**ADDENDUM NO. 3**  
**GEORGETOWN ELEMENTARY SCHOOL**  
**CLASSROOM & KITCHEN ADDITIONS**  
Georgetown, Delaware 19947

May 27, 2015

The documents for the above referenced project, Project Manual, dated March 2, 2015 and Drawings, dated April 10, 2015, and subsequently issued addenda are amended as follows:

EL102  
COPYRIGHT © 2015

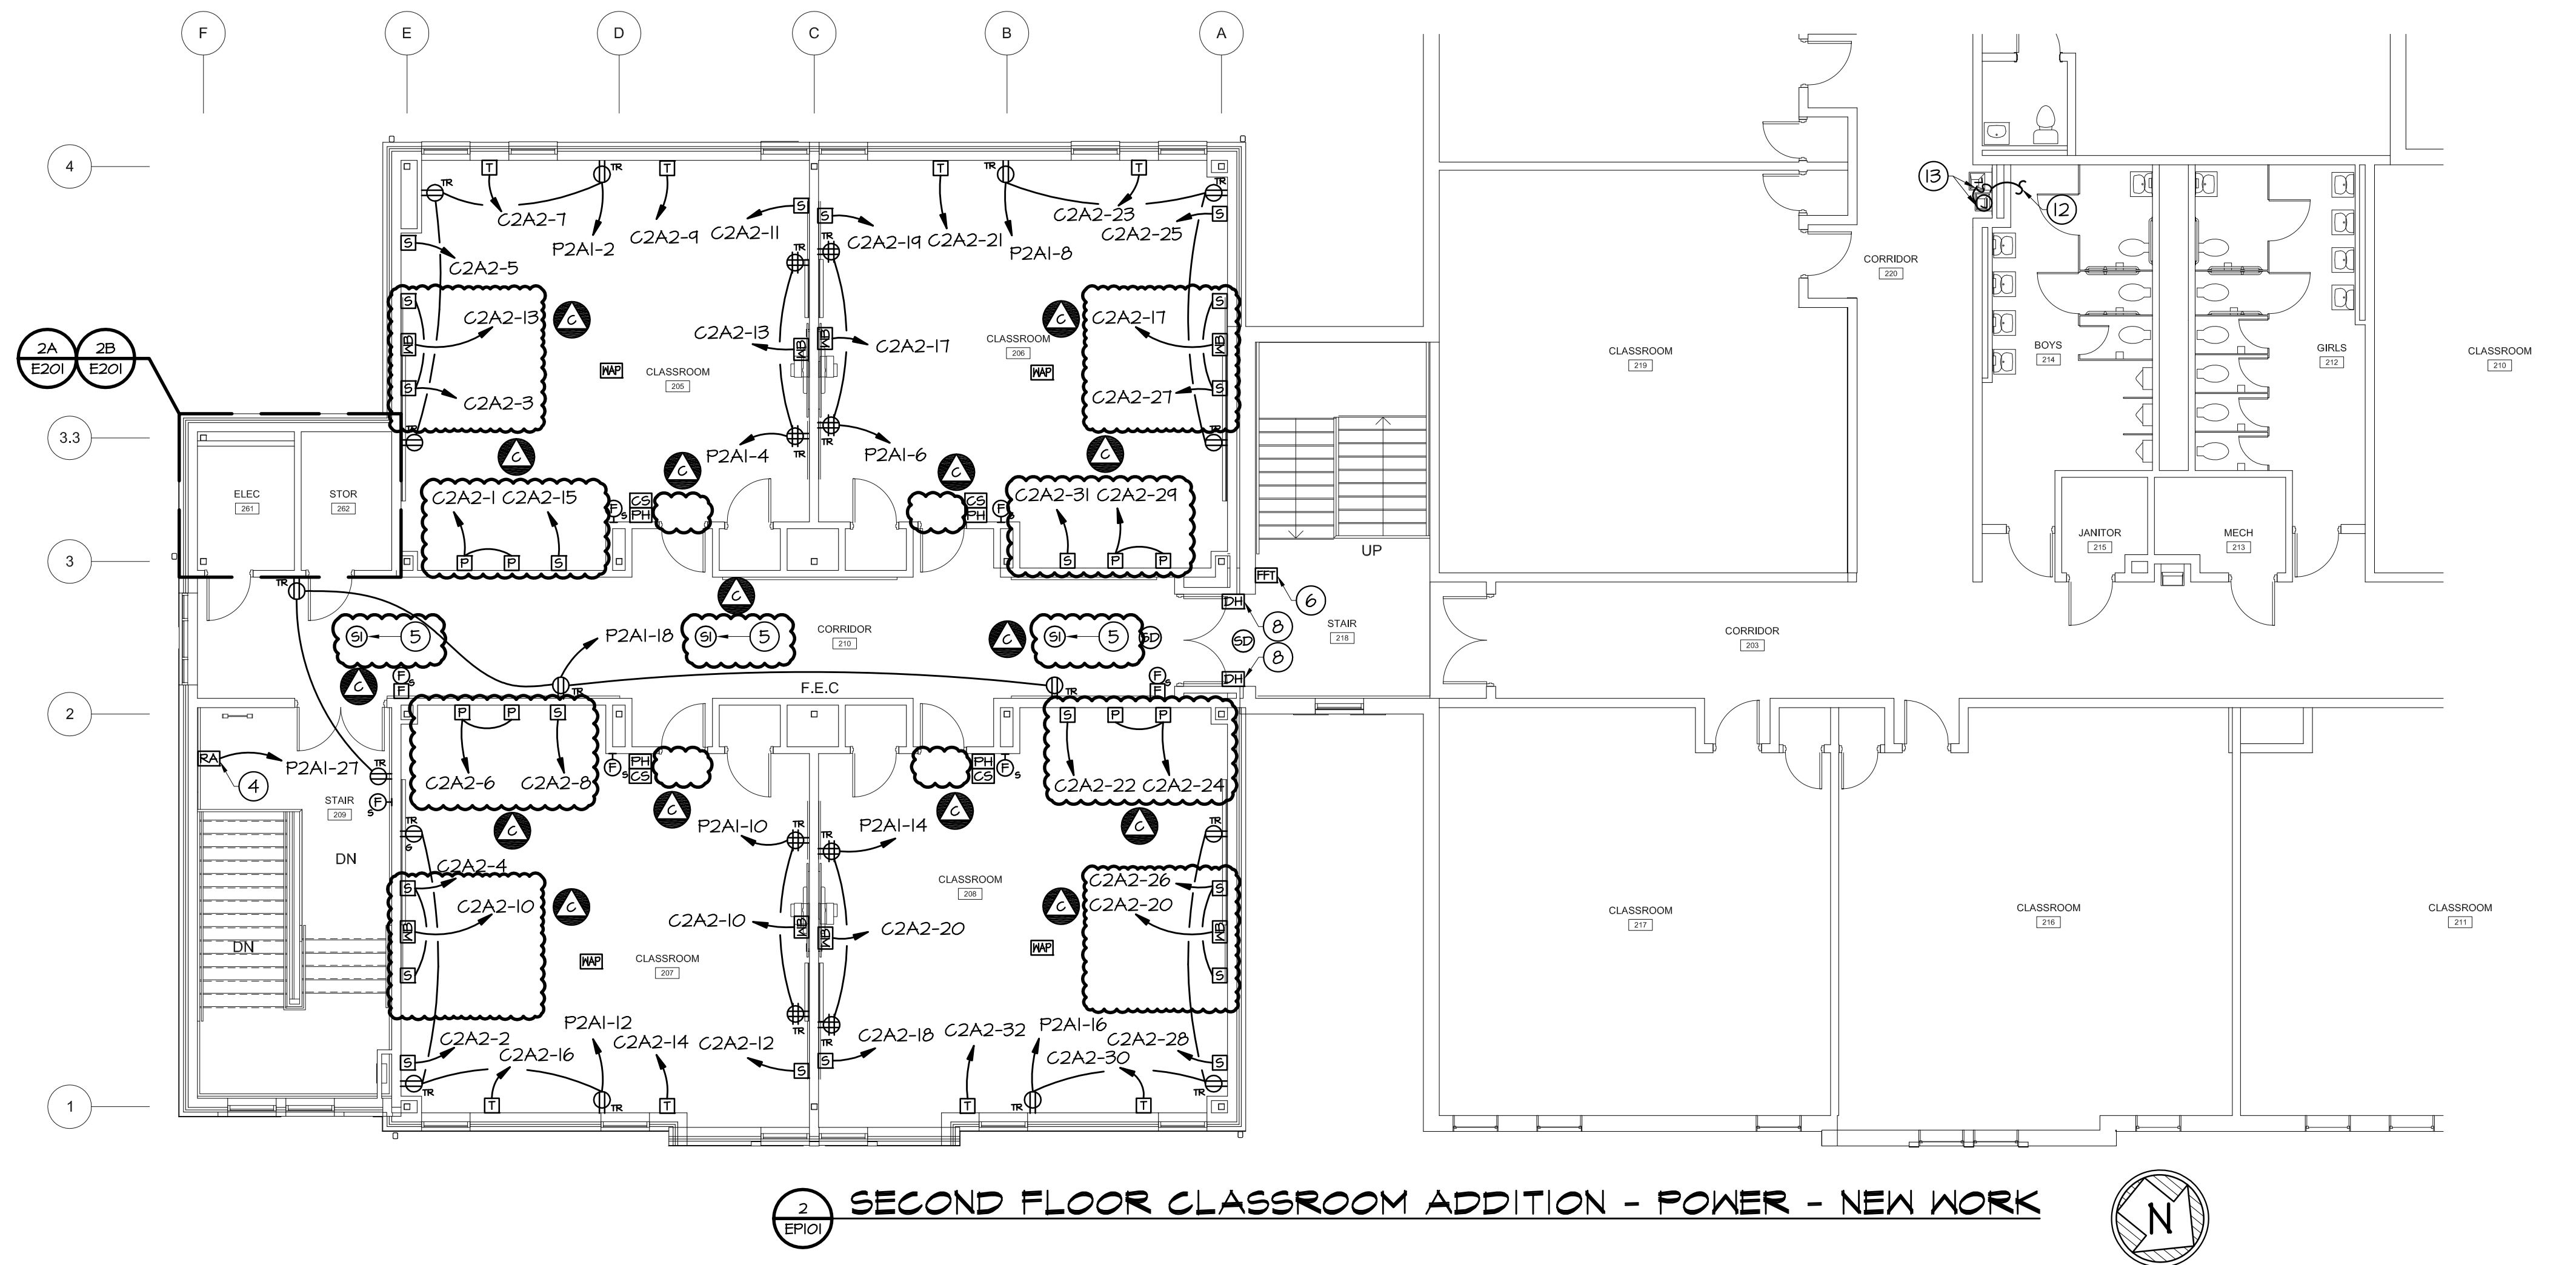
- 23. EL102 – Kitchen Addition Lighting New Work:
  - a. REPLACE Drawing EL102 in its entirety with revised Drawing EL-102. Changes made to this sheet reflect the new work lighting changes required based on the latest architectural plans for the existing toilet rooms ceilings and alternate 4.
